**CITY OF SAINT PETER, MINNESOTA  
AGENDA AND NOTICE OF MEETING**

**RE:** Standard Detail Updates for 2014

The City has standard details that are used for construction of public infrastructure through out the City. Recently the American Disabilities Act (ADA) required changes in public standards; it is the City's intention to stay in compliance with ADA requirements and the changes are reflected in the following City standards.

STANDARD DETAIL  
PLATE NO:  
**0001**

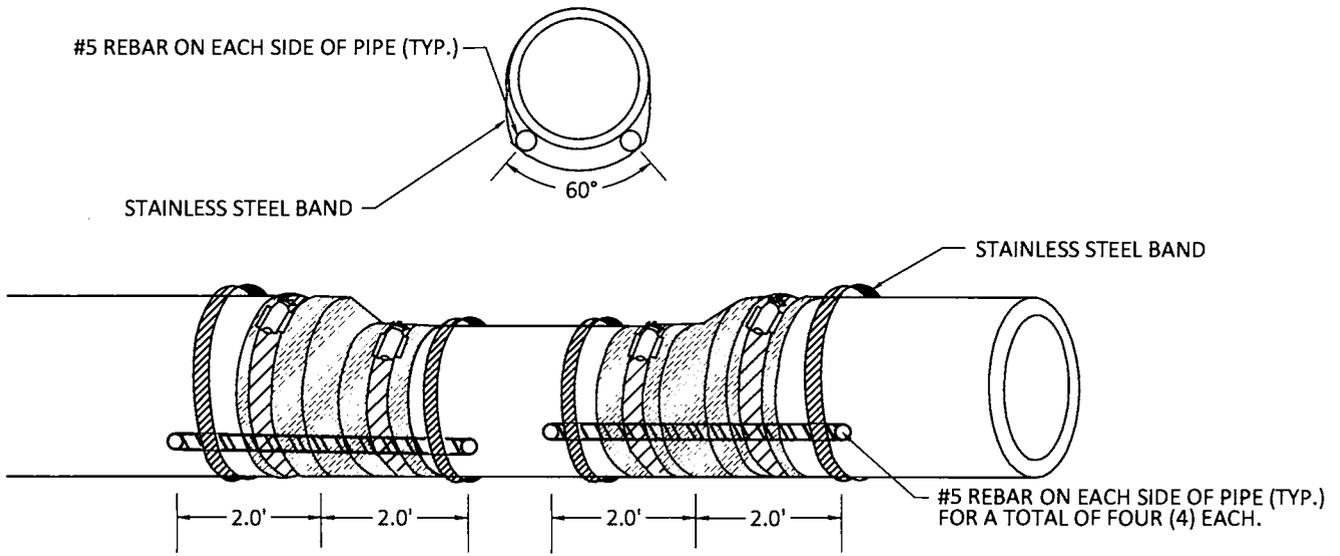
0001 –Eccentric Fernco Splint

Added: #5 Rebar on each side of pipe (TYP.) for a total of four (4) each.

STANDARD DETAIL  
PLATE NO:  
**0002**

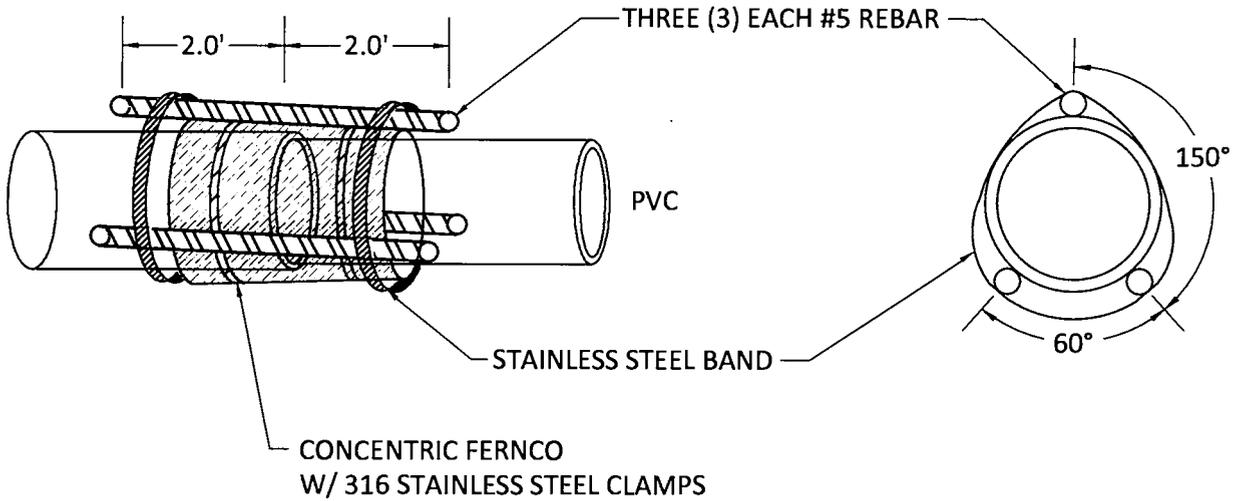
0002 – Concentric Fernco Splint  
Dome area adjacent to curb

Added: #5 Rebar

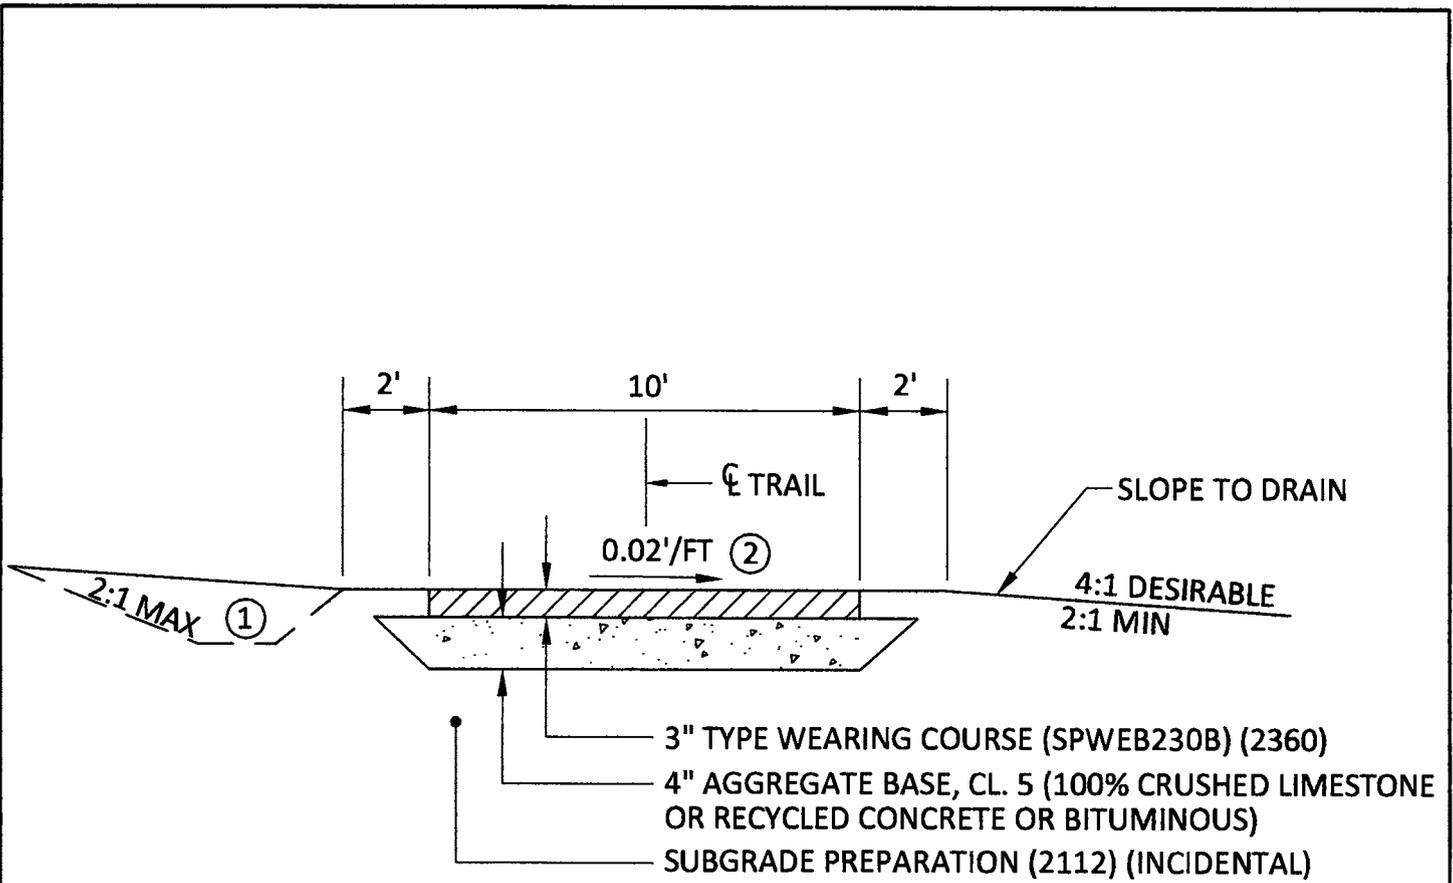
1001 – Bituminous Trail Detail

Added: or recycled concrete or bituminous

STANDARD DETAIL  
 PLATE NO:  
**2001**

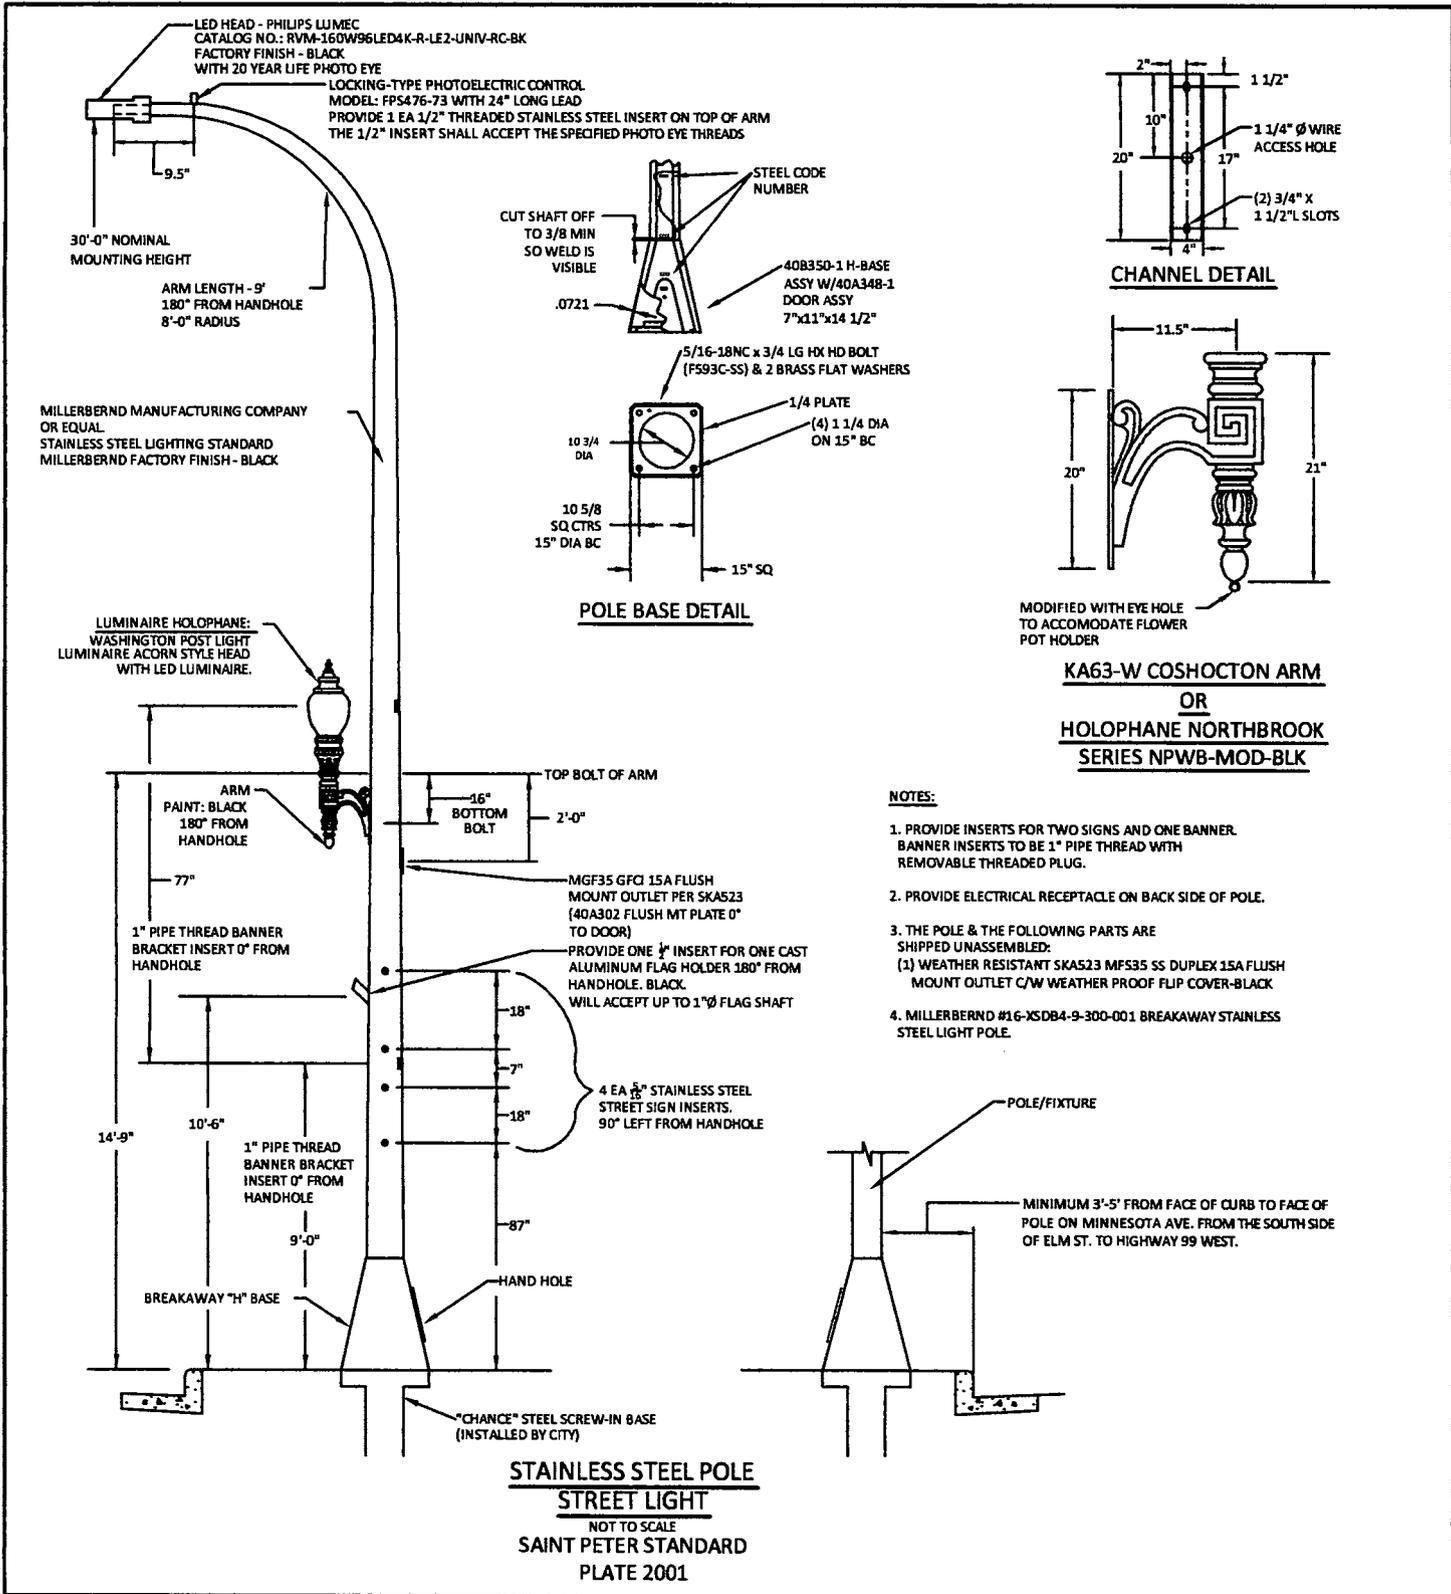
2001 – Stainless Steel Pole Street Light

Added: LED Head – Phillips Lumec catalog  
NO. 160W96LEDK-R-LE2-UNIV-RC-BK  
Factory finish – Black  
With 20 Year life photo eye

STANDARD DETAIL  
PLATE NO:  
**4006**

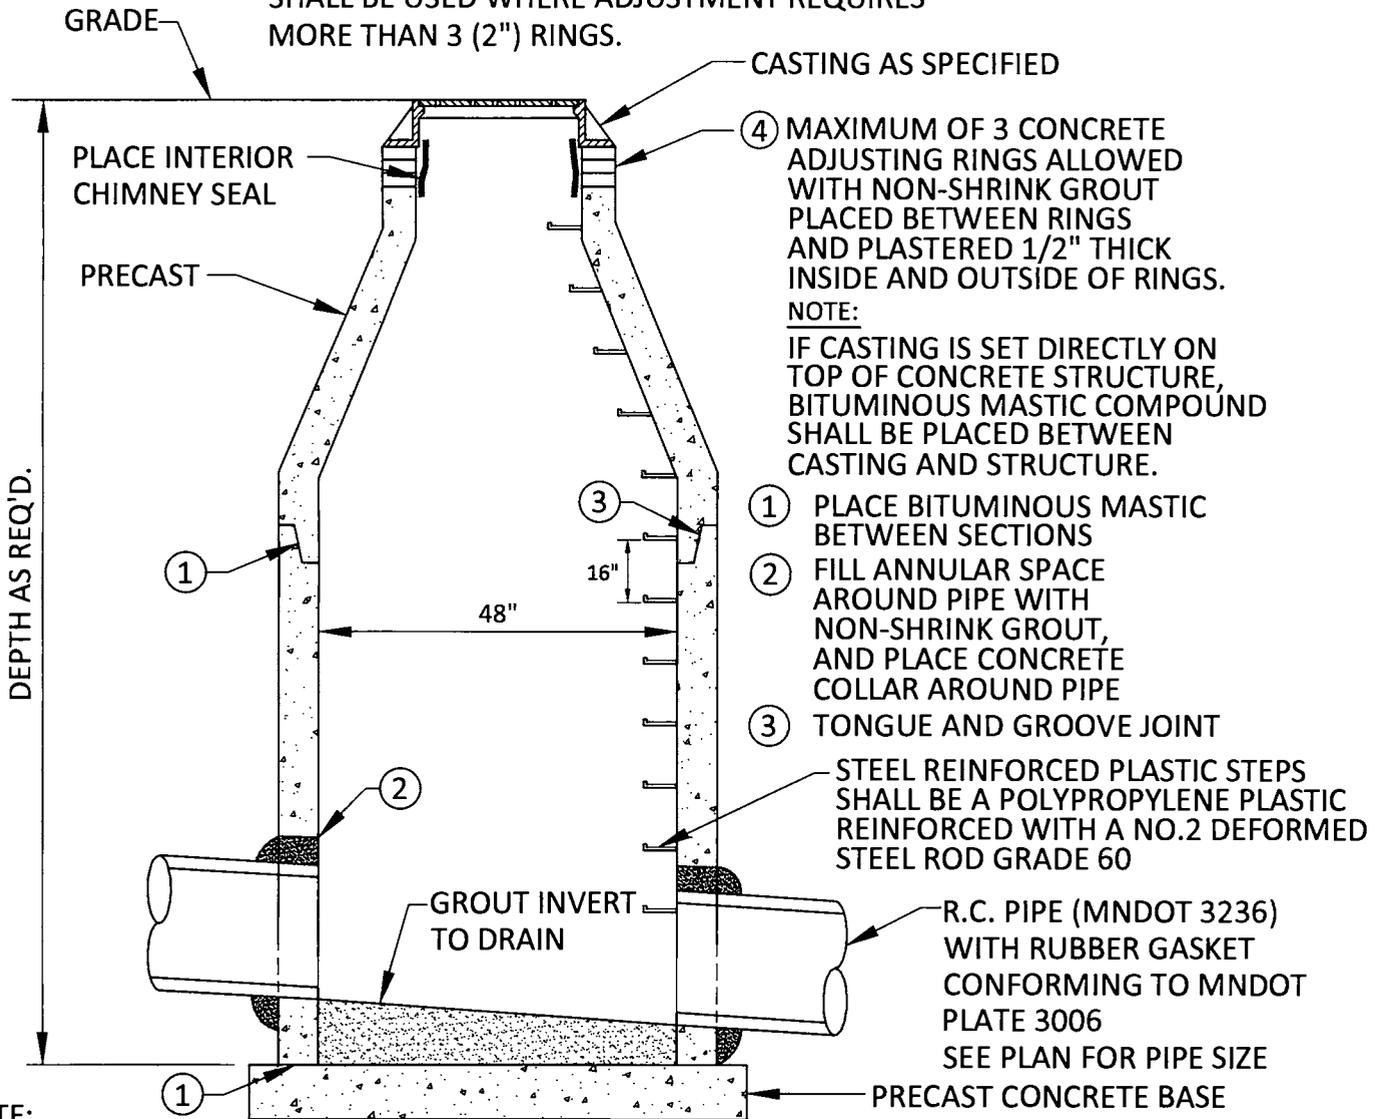
4006 – Storm Sewer Design F Manhole

Added: Note 3 – Tongue and groove joint

STANDARD DETAIL  
PLATE NO:  
**7017**

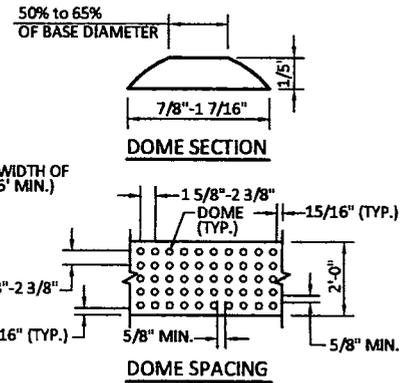
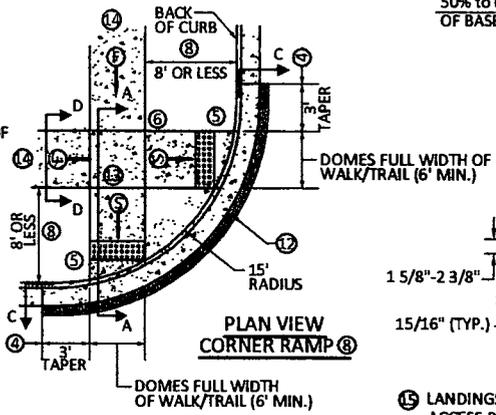
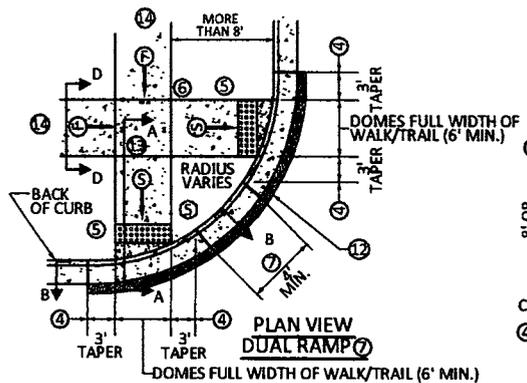
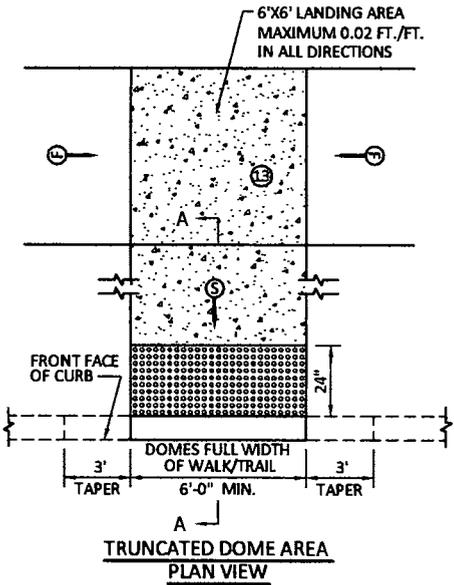
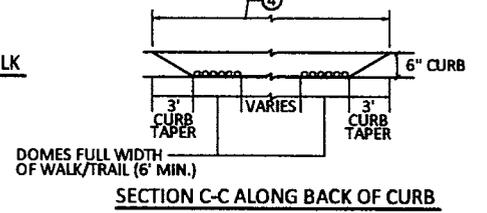
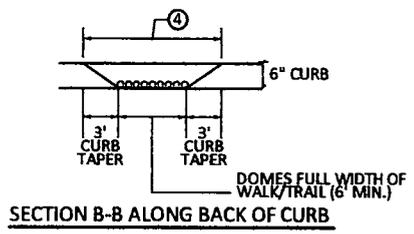
7017 – Pedestrian Curb Ramp with Truncated Dome area

Reworded Note #11 – The construction of a new or reconstruction of an existing pedestrian ramp will not be allowed unless a pedestrian ramp meeting city standards is located on the opposite side of the street from the ramp being proposed. In the event no ramp exists a new ramp meeting city standards shall be constructed (See detail 7017B)

Added: Note #13

Added: Note #14

Added: Note #15

Added: Note #16

Added: Legend – These longitudinal slope ranges shall be the starting point. If site conditions warrant, longitudinal slope s up to 8.3% for flatter are allowed

Added: Note S

Added: Note F

STANDARD DETAIL  
PLATE NO:  
**7017A**

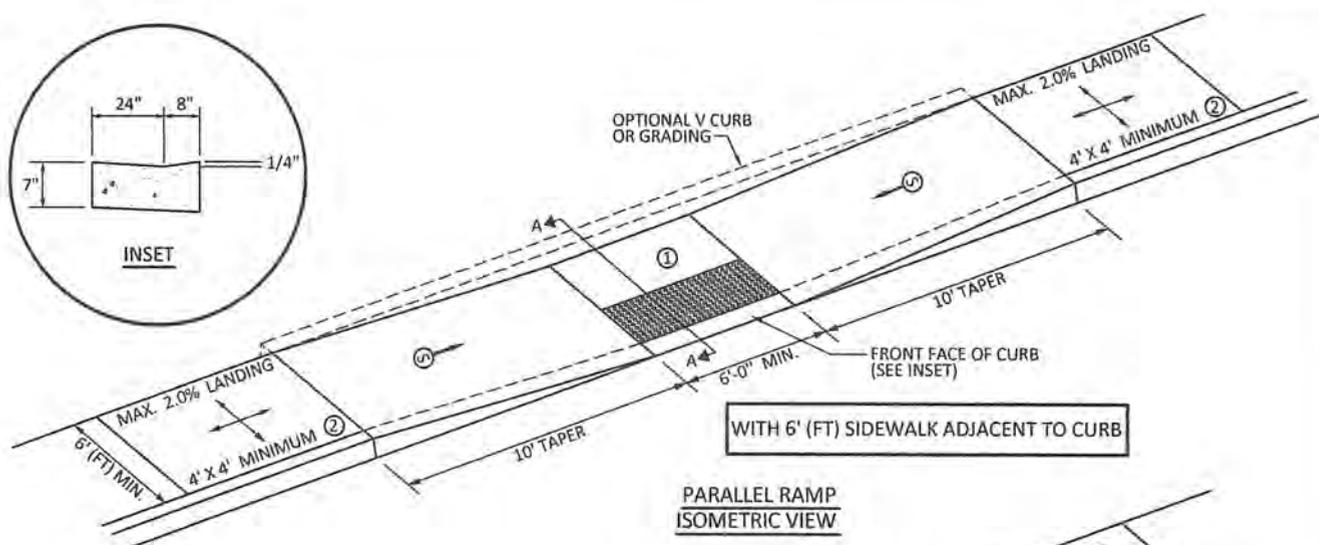
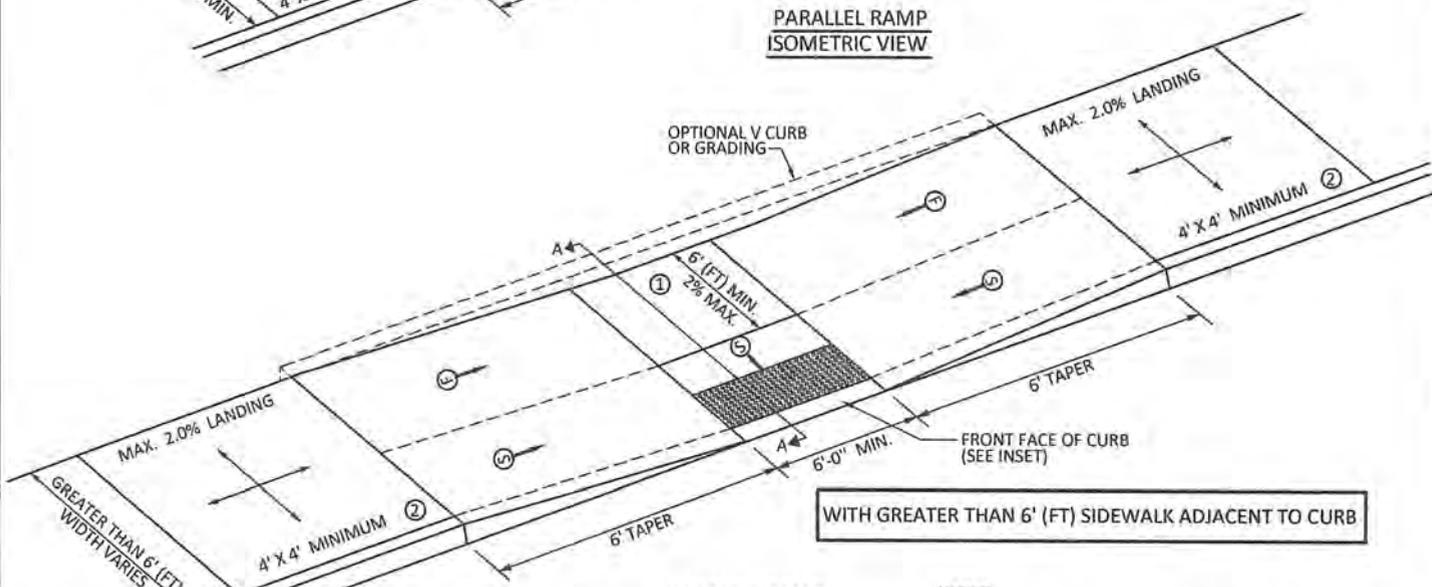
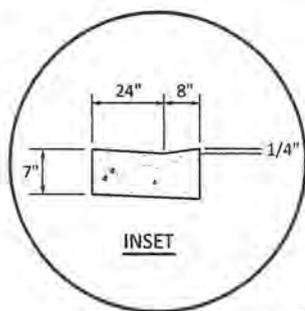
7017A – Pedestrian Curb Ramp with Sidewalk Adjacent to Curb

Added: or recycled concrete or bituminous

Added: Legend – These longitudinal slope ranges shall be the starting point. If site conditions warrant, longitudinal slope s up to 8.3% for flatter are allowed

Added: Note S

Added: Note F

Added: Note #1

Added: Note #2

Added: Note #3

Added: Note #5

STANDARD DETAIL  
 PLATE NO:  
**7017B**

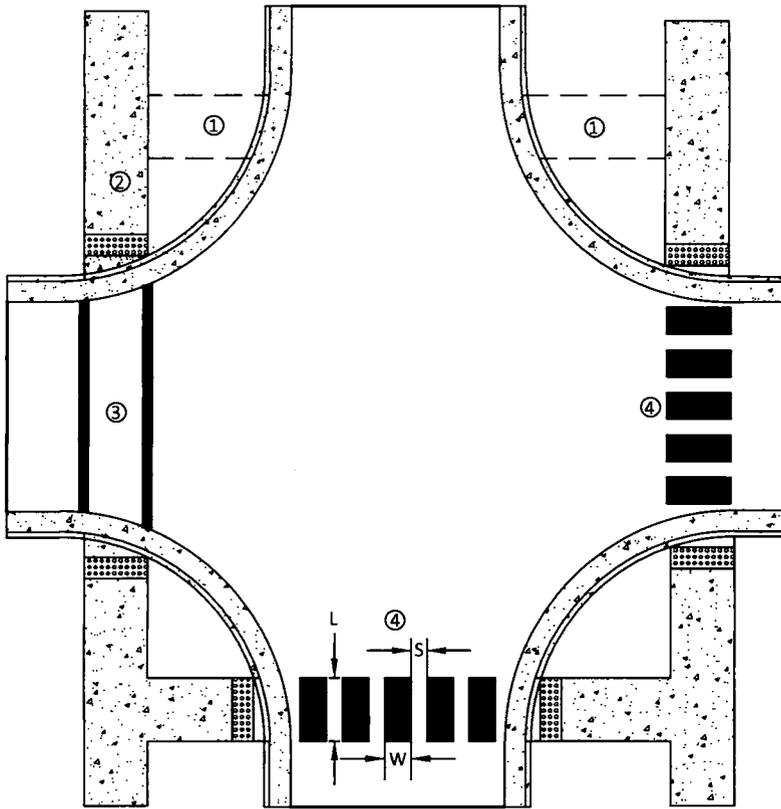
7017B – Intersection Pedestrian Ramp and Crosswalk Requirements

New
